MECKLENBURG COUNTY HEALTH DEPARTMENT

SITE INVESTIGATION REPORT
INDIVIDUAL SEPTIC TANK SYSTEM
WITH SUBSURFACE,
SOIL ABSORPTION,
EFFLUENT DISCHARGE

SUBJECT: APT 9249 (Bob McLemore & Co., Inc.)
Mountain Apple Drive
Lot 5, Block C
Date: 5/2/75

SOIL INVESTIGATION REPORT

See Diagram on Back

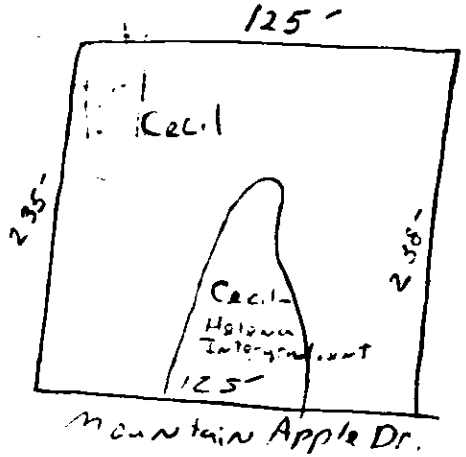
The lot consists of soils of the Cecil series and soils intergrading between the Cecil and Helena series.

The soils intergrading between the Cecil and Helena show indications of containing a small amount of expanding clay minerals which result in limited permeability and percolation rate. The Cecil soils have good aeration, good drainage, and moderate permeability. The lot, howver, has been inundated with a poorly drained condition over the entire lot due to the normal drainage pattern being blocked by permenant road structures. These physical limitations place severe restrictions on installation of a septic tank system. Suitable conditions can be returned by diverting water off the lot.

Based on this investigation, the lot is not recommended for approval for installation of a septic tank system.

Recommendations Based on this investigation, the lot is not recommended for approval for installation of a septic tank system. It should be noted however, that the problem of drainage can be remedied and the lot can then be utilized.
